LOGOS Apparels Ltd.(New buildings)

TELIRCHALA, MOUCHAK, KALIAKOIR, GAZIPUR
(24.016202, 90.305371)

29th January 2019 & 5th February 2019

Observations

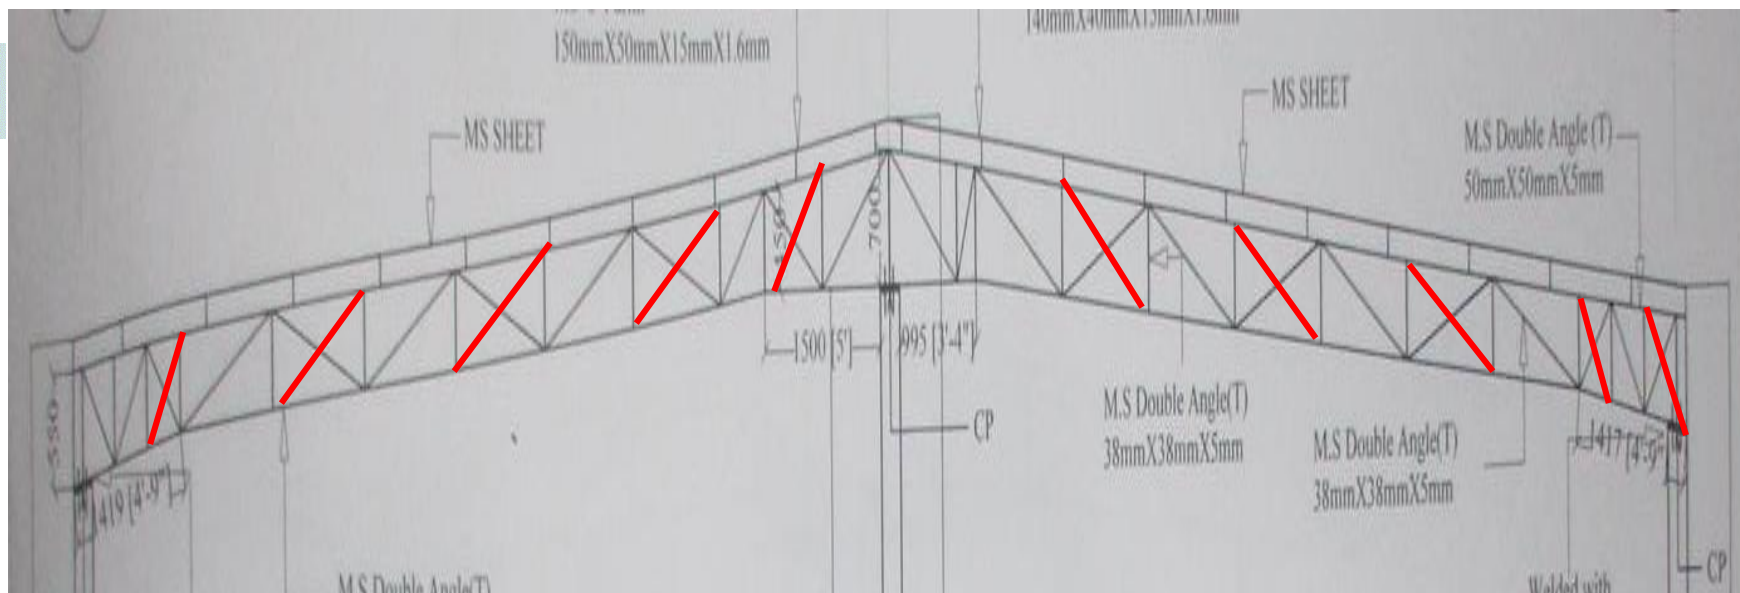
Tie beam was not found at marked location. But tie beam has been shown in as-built drawing.

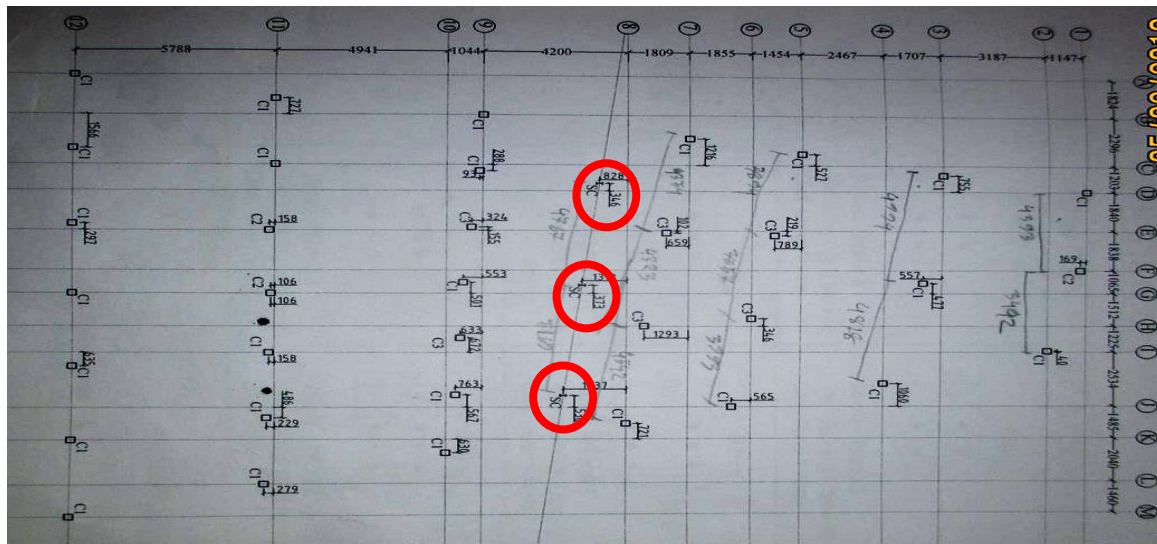
Three steel column constructed on 1st floor slab

Three steel column started from 1st floor to 2nd floor level. No adequacy check of slab was found. Factory engineer is required to check adequacy of the slab to bear load from steel column.

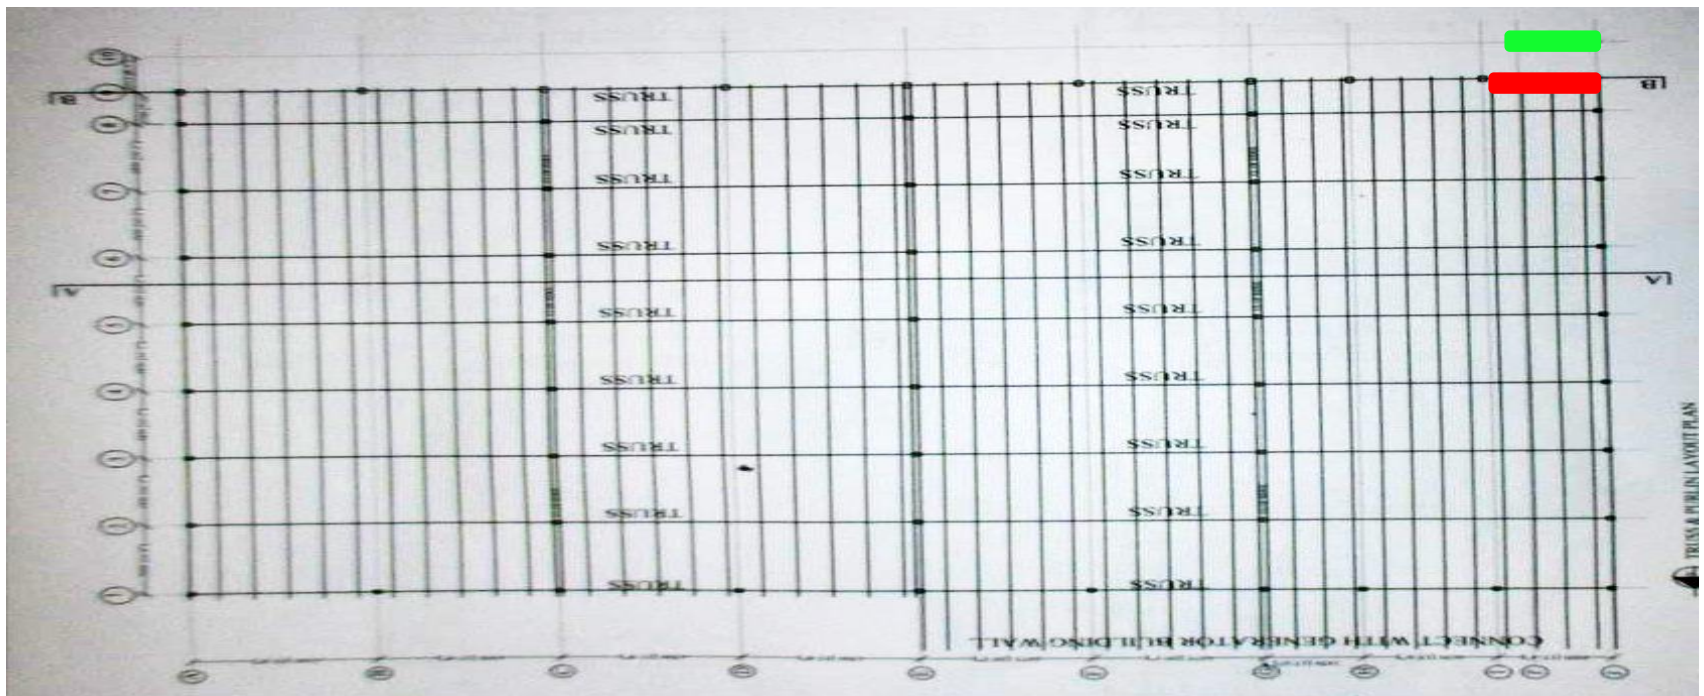
Truss layout plan; Additional truss found at grid 10 instead of Grid-9 at marked location. Truss was found at green marked location instead of red marked location.
